Re: Memorandum in Response to the Auckland Council Ecology Pre-App Meeting on 25/11/2025

This memorandum responds to item 6 in the meeting minutes prepared by Barker and Associates, addressing matters raised by Mr. Rue Statham, Auckland Council’s terrestrial ecology specialist, concerning public walkways, offsets, and additional planting within the existing Stage 2 consent notice area.

Figure 2 - Additional areas for planting around the Stage 2 consent notice area

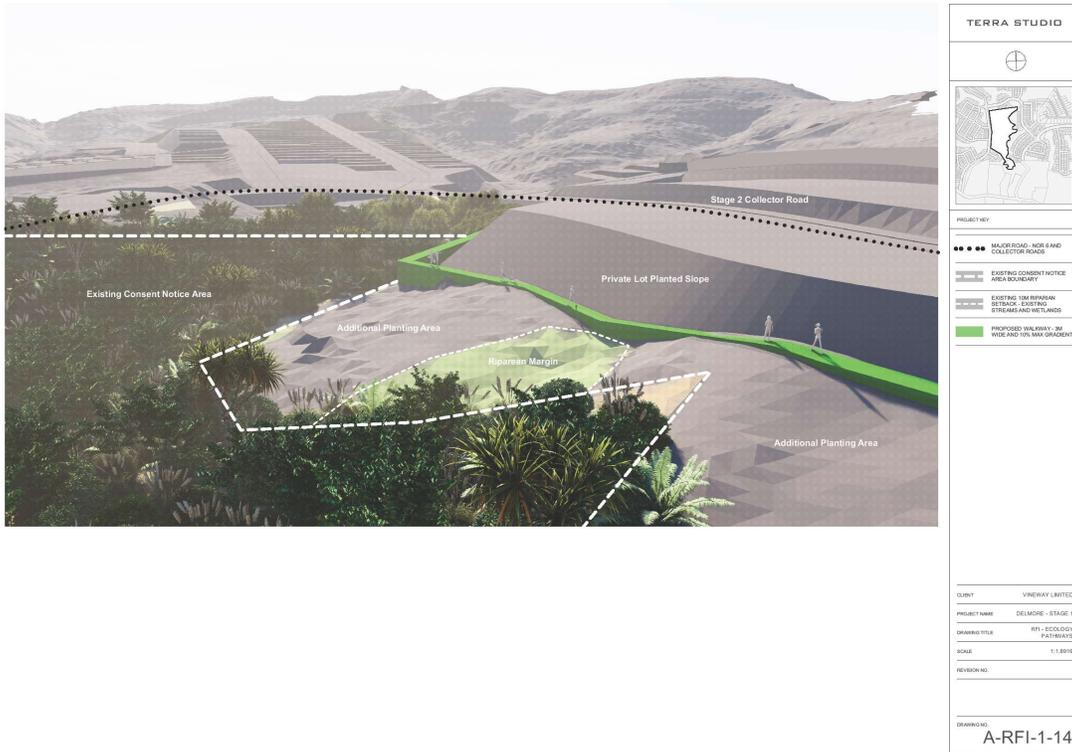
The existing steep topography in Stage 2A-1 requires the proposed residential lots to the east of the consent notice area to be set back using planted batter slopes. In response to recommendations from Mr. Statham, the applicant has proposed a public pedestrian walkway along the base of the private batter slopes to ensure passive surveillance of the protected vegetation while providing additional amenity for the residents. The proposed walkway achieves maximum gradients of 10% and includes small bridge structures where stream crossings are required. The walkway connects the northern portion of the Stage 2 collector road / Road 05 to the paper road and future NOR 6 extension.

There are 46 houses located along the eastern consent notice area boundary that all achieve a 10m setback from the house to the consent notice area. Additionally, 40 of the 46 houses achieved 20m setbacks (87%), 27 of the 46 houses achieve 30m setbacks (59%) and 20 of the 46 houses achieve 40m.
